# UNITED STATES PATENT AND TRADEMARK OFFICE

APPLICATION NO.	FILING DATE	FIRST NAMED INVENTOR	ATTORNEY DOCKET NO.	CONFIRMATION NO.
10/683,603	10/10/2003	Nazim Z. Muradov	UCF-269DIV	1031
23717	7590	04/25/2006	EXAMINER	
LAW OFFICES OF BRIAN S STEINBERGER 101 BREVARD AVENUE COCOA, FL 32922			ALEJANDRO, RAYMOND	
			ART UNIT	PAPER NUMBER
			1745

# Office Action Summary

## DETAILED ACTION

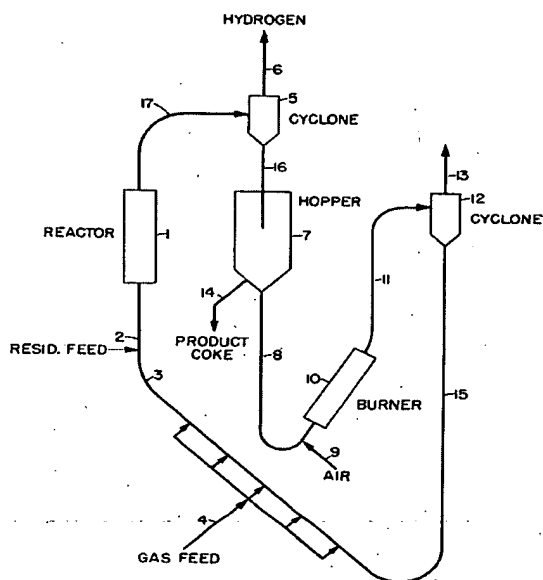
Krebs discloses production of hydrogen and coke (TITLE) by cracking of gaseous hydrocarbon over coke particles by the addition of heavy hydrocarbon oils (COL 1, lines 15-18) to form products consisting of hydrogen and carbon (COL 1, lines 19-22). Krebs uses a fluidized

bed reactor (COL 2, lines 25-28). Coke is in the form of a fluidized stream (COL 2, lines 29-31). In the reactor 1, hydrogen is evolved and the residuum feed is cracked and the carbon produced in the process is coated on the solid coke particles (COL 2, lines 30-35). The reaction products, hydrogen together with other vaporous products are sent through line 17 into cyclone 54 which is a solid/vapor separating device (COL 2, lines 33-38).

As illustrated in **Figure 1** below, solid/vapor separating devices 5 and 12 separates the hydrogen product from the remaining residual gas (COL 2, lines 36-38/ COL 2, lines 48-52). Thus, they recover hydrogen produced in the reactor. Lines 8, 11, 15 recycles the hydrogen-depleted gas to the reactor 1. Solid/vapor separating devices 5 and 12 separates the hydrogen product from the remaining residual gas. Burner 10 heats a portion of the carbon product contained in the first hydrogen-depleted gas in line 8 and 11.

Cokes is withdrawn from hopper 7 through standpipe 8 and transported into conduit 10, a transfer line burner (COL 2, lines 40-45). Krebs use the dusty carbon black product incorporated with the hard coke from the residue to form useful recoverable coke product (Col 1, lines 45-48).

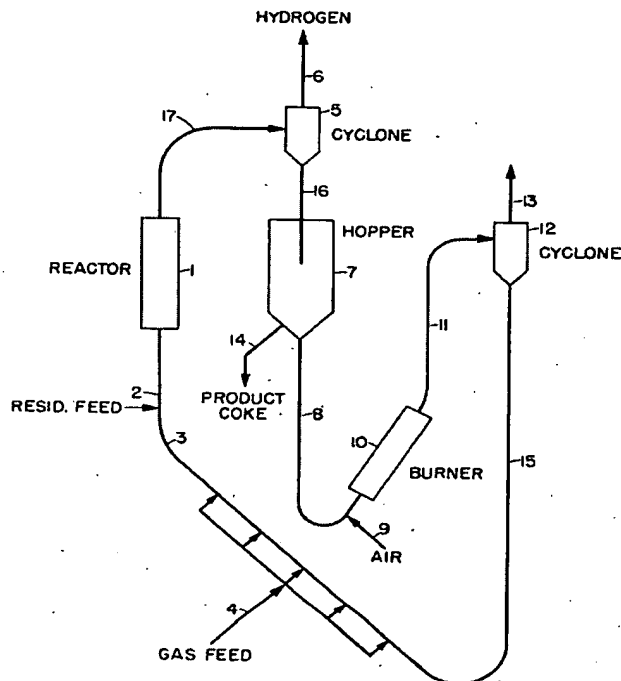
Krebs discloses production of hydrogen and coke (TITLE) by cracking of gaseous hydrocarbon over coke particles by the addition of heavy hydrocarbon oils (COL 1, lines 15-18) to form products consisting of hydrogen and carbon (COL 1, lines 19-22). Krebs uses a fluidized bed reactor (COL 2, lines 25-28). Coke is in the form of a fluidized stream (COL 2, lines 29-31). In the reactor 1, hydrogen is evolved and the residuum feed is cracked and the carbon produced in the process is coated on the solid coke particles (COL 2, lines 30-35). The reaction products, hydrogen together with other vaporous products are sent through line 17 into cyclone 54 which is a solid/vapor separating device (COL 2, lines 33-38).

As illustrated in **Figure 1** below, solid/vapor separating devices 5 and 12 separates the hydrogen product from the remaining residual gas (COL 2, lines 36-38/ COL 2, lines 48-52).

Thus, they recover hydrogen produced in the reactor. Lines 8, 11, 15 recycles the hydrogen-depleted gas to the reactor 1. Solid/vapor separating devices 5 and 12 separates the hydrogen product from the remaining residual gas. Burner 10 heats a portion of the carbon product contained in the first hydrogen-depleted gas in line 8 and 11.

Cokes is withdrawn from hopper 7 through standpipe 8 and transported into conduit 10, a transfer line burner (COL 2, lines 40-45). Krebs use the dusty carbon black product incorporated with the hard coke from the residue to form useful recoverable coke product (Col 1, lines 45-48).
